# Grimes Planning and Zoning Commission

## **Planning and Zoning Commission September 22, 2022 In Person at Grimes Community Complex, 410 SE Main Street, Room 202**

TO: Planning and Zoning Commission  
FROM: Molly Mannel, Assistant Planner  
DATE: September 6, 2022  
RE: Rock Creek Plat 1 – Preliminary Plat

TO: Planning and Zoning Commission  
FROM: Molly Mannel, Assistant Planner  
DATE: September 6, 2022  
RE: Rock Creek Building 1 – Site Plan

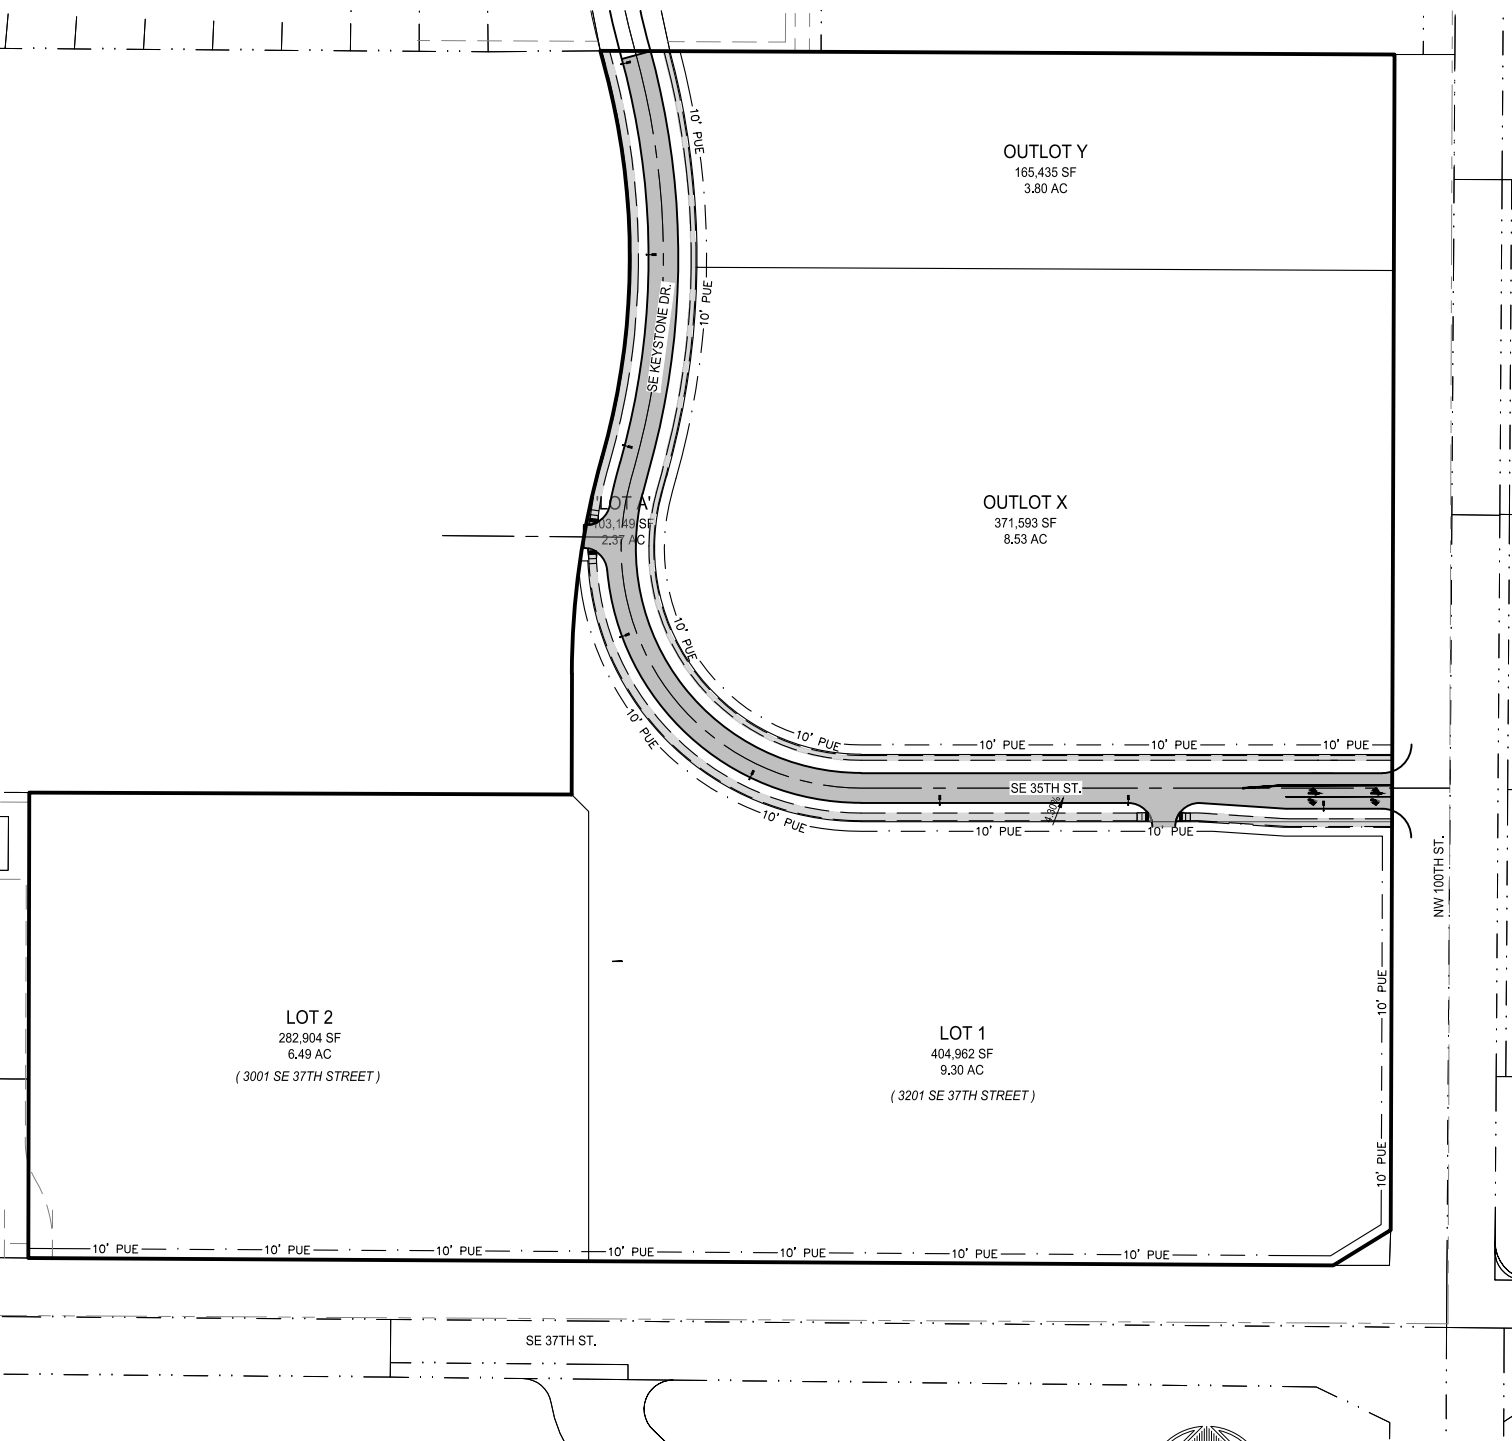
1. ~~Please update the zoning to C-2 and the Transportation Corridor Mixed Use Development Overlay District.~~
2. ~~Update property owner information.~~
3. Please provide parking calculations. Please delineate patient, visitor, and staff parking. 10% of hospital outpatient parking is required to be ADA. Please list the following parking calculations on the cover sheet:
  - i. 157 patient/visitor stalls (and 18 patient/visitor ADA stalls)
  - ii. 154 staff stalls (and 6 staff ADA stalls)
4. ~~Update plat name to Rock Creek Plat 1.~~

DRAWING NO.  
**PP-02**

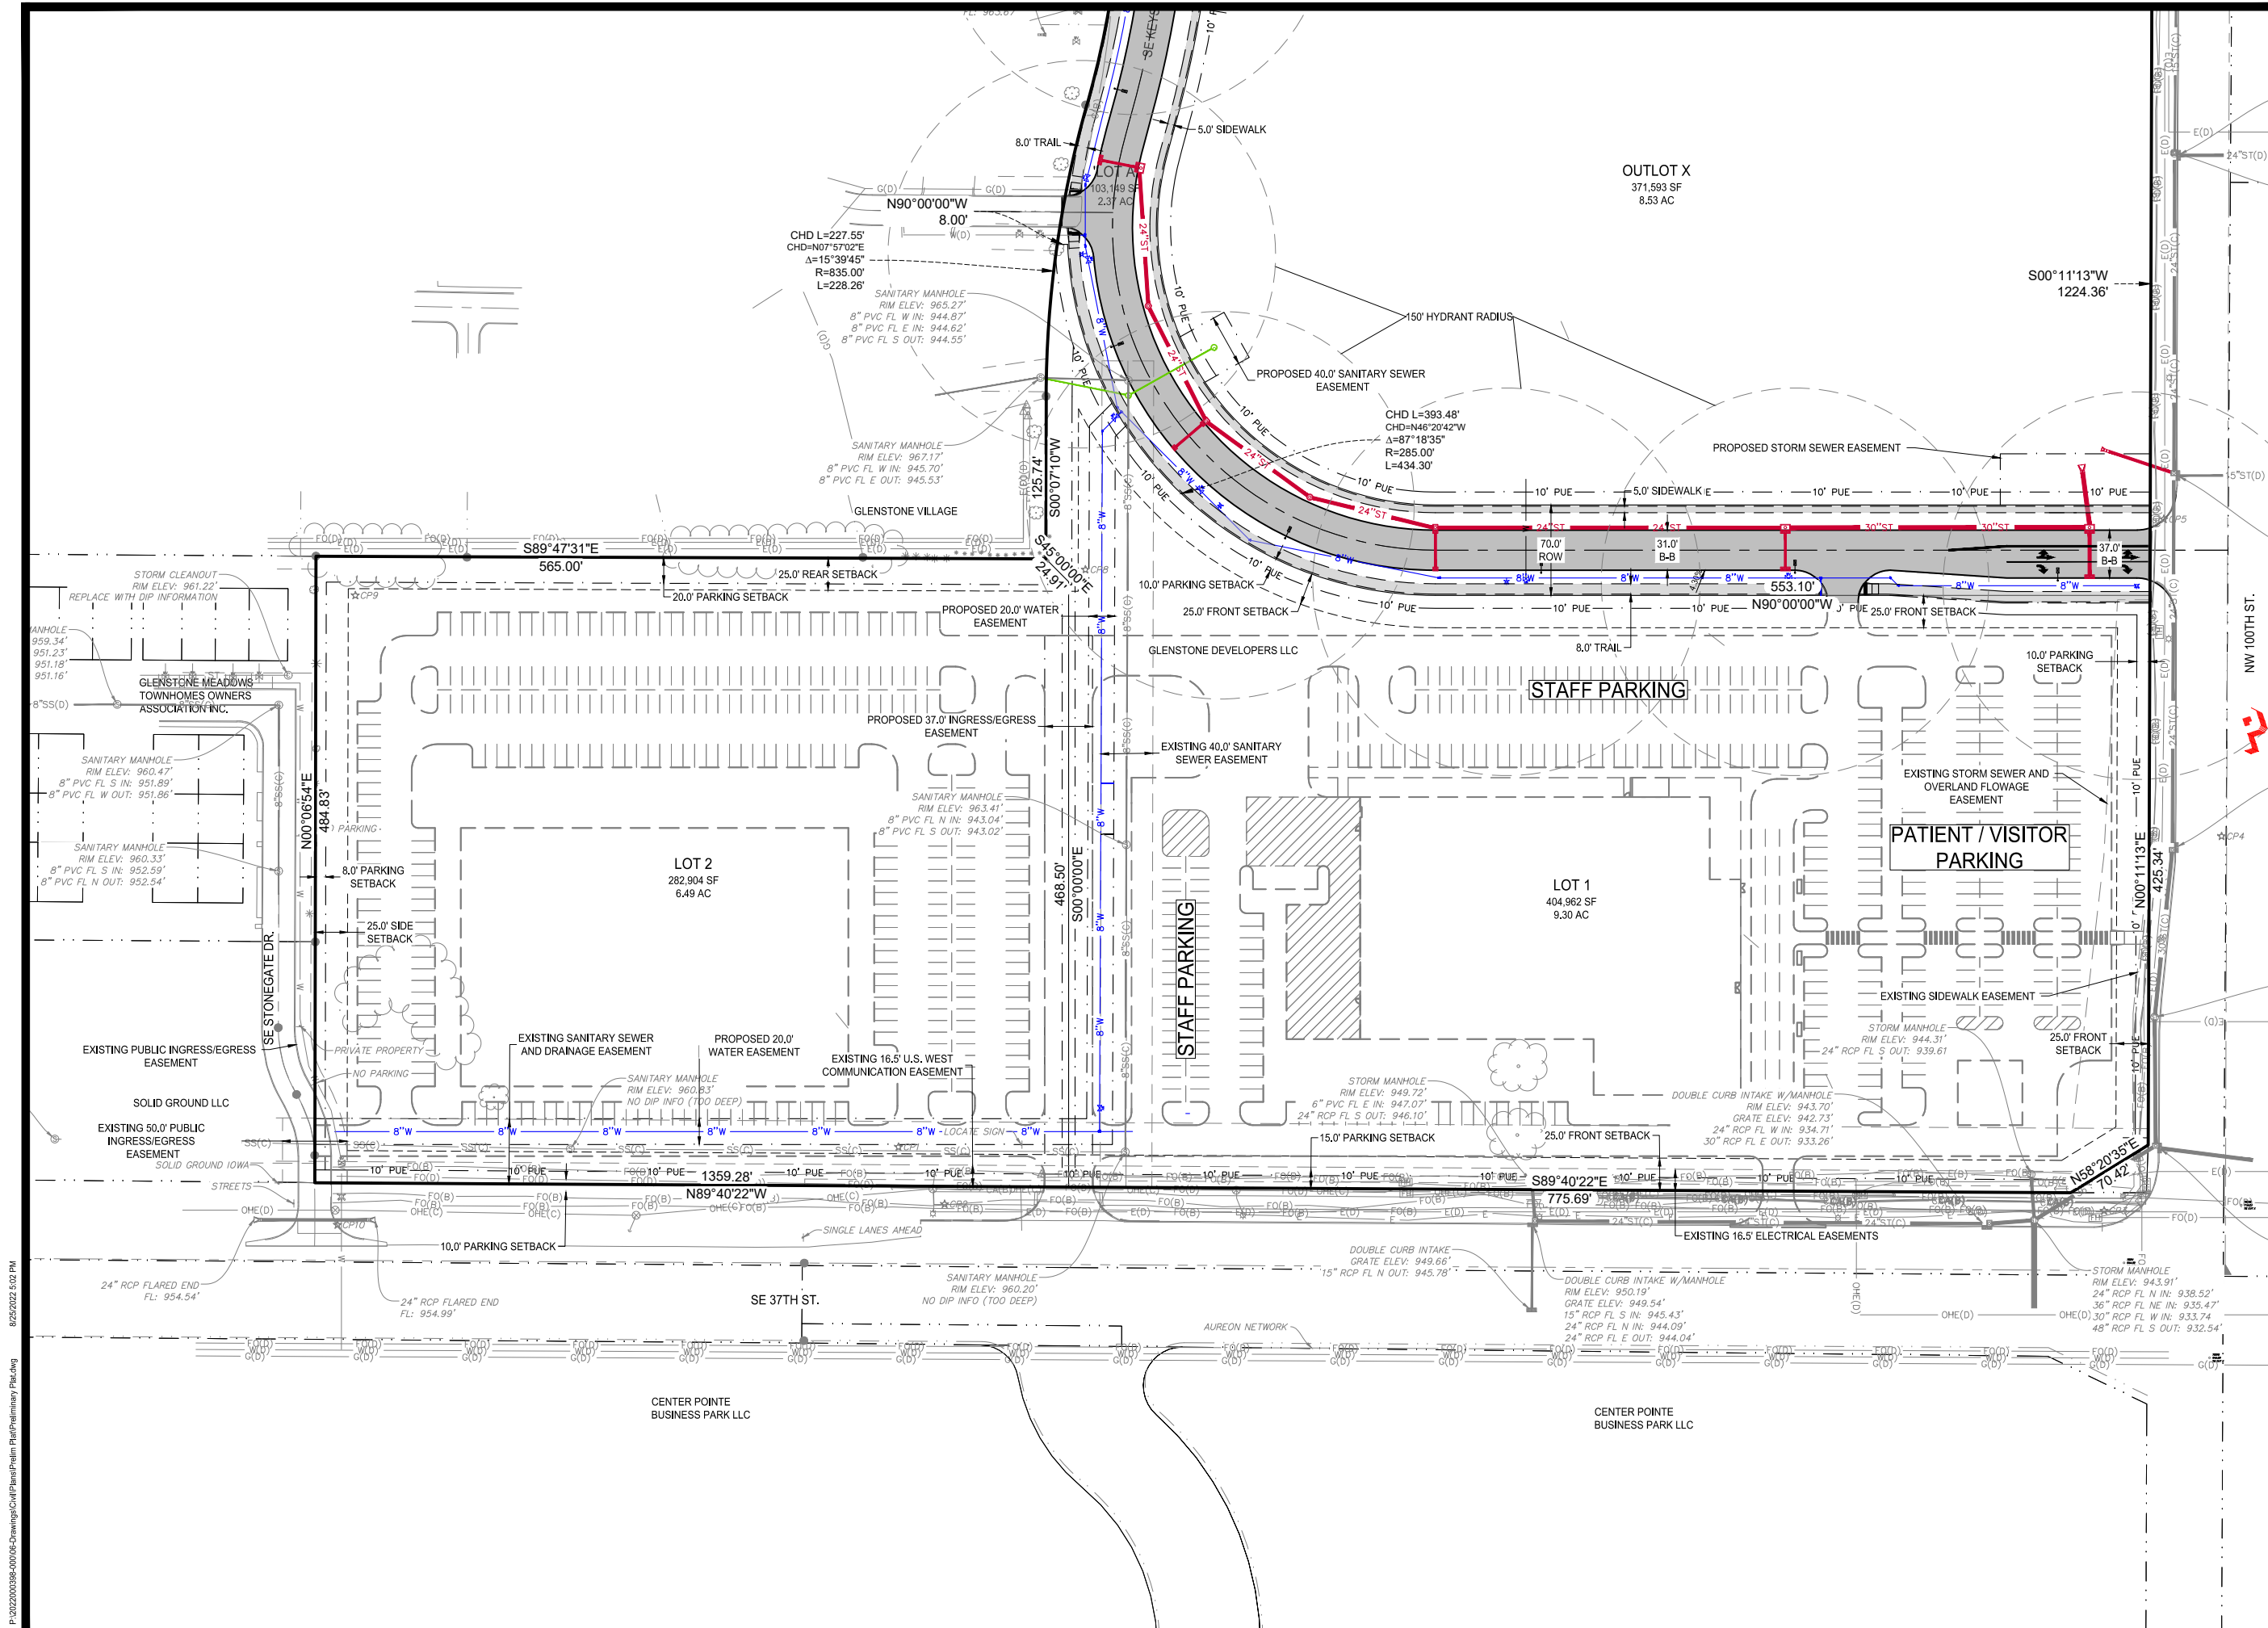
1. Revise the 10' parking setback label along SE 37<sup>th</sup> St. It is shifted south too far. The label was not shifted. Please fix. Please change the label from 15' parking setback to 10' parking setback. The parking setback line and remain where it is.

3. ~~Label the existing 50' by 50' ingress/egress easement at the southwest corner of the site.~~
4. ~~Revise 5' parking setback to 8' parking setback along the west property line.~~
5. Please label SE 35<sup>TH</sup> Street.

**1 TYPICAL PAVING SECTIONS (31' & 37' BACK TO BACK PAVEMENT)**  
NOT TO SCALE

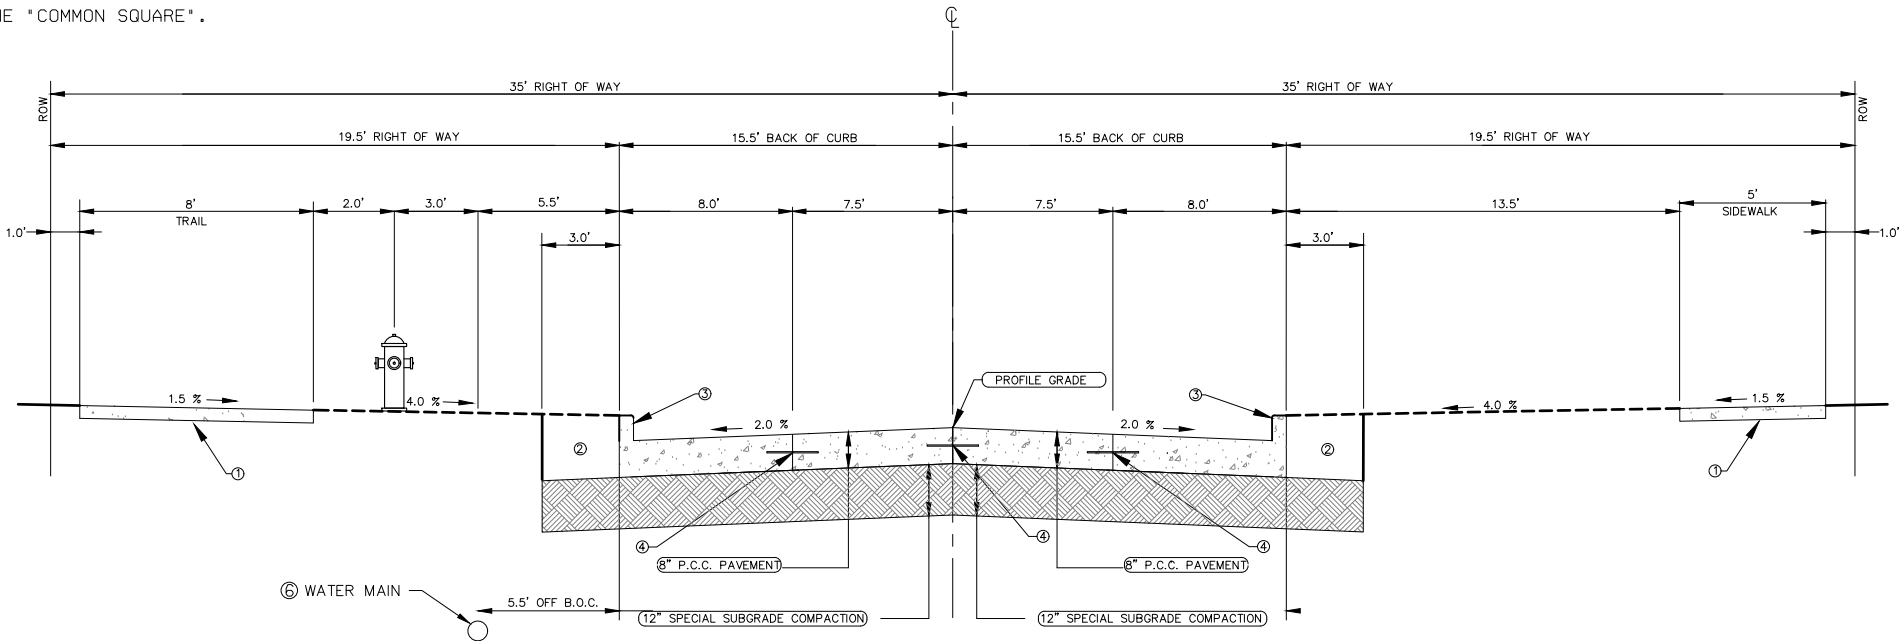
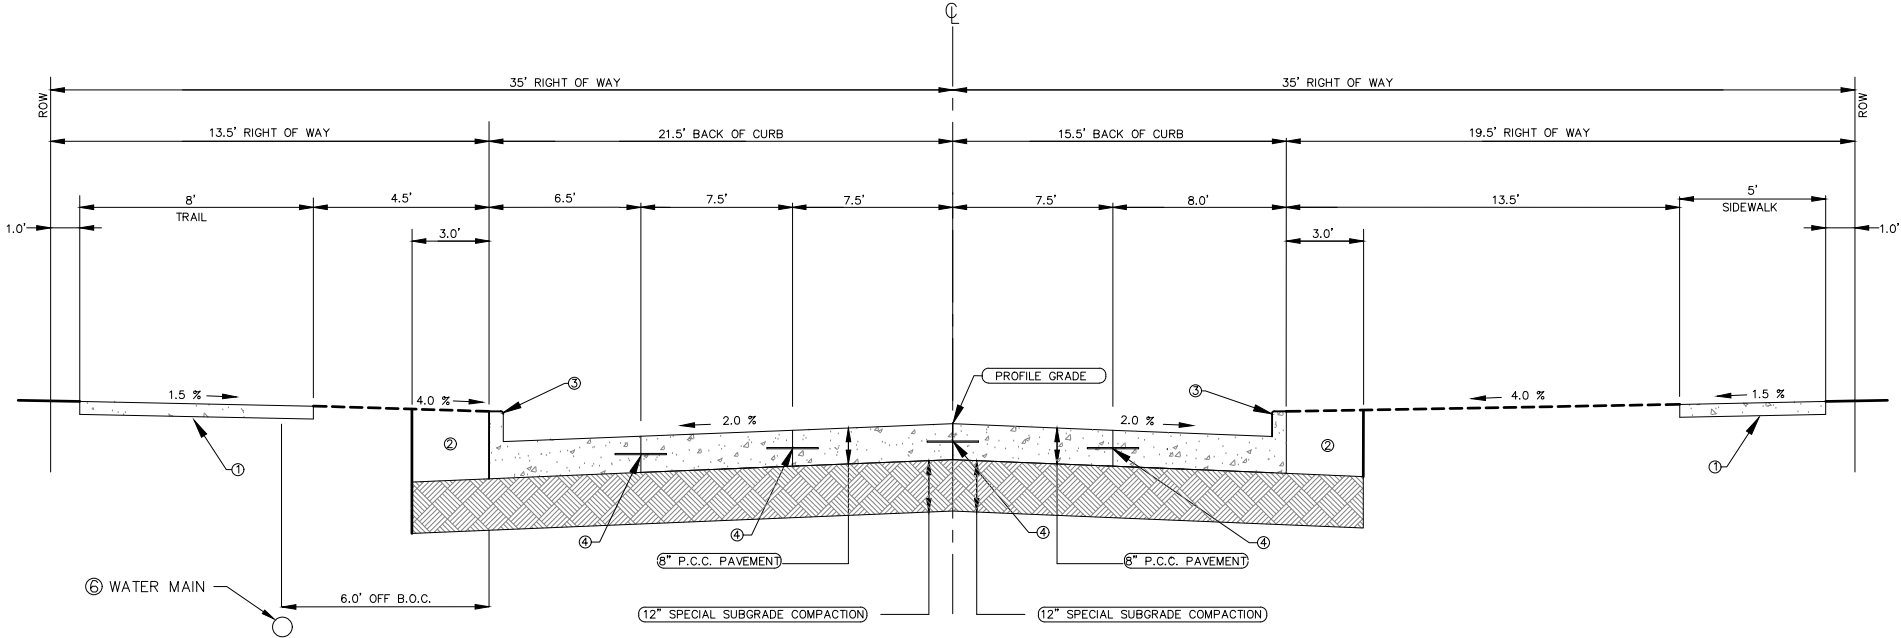
1. ~~Please also provide a 37' typical section.~~
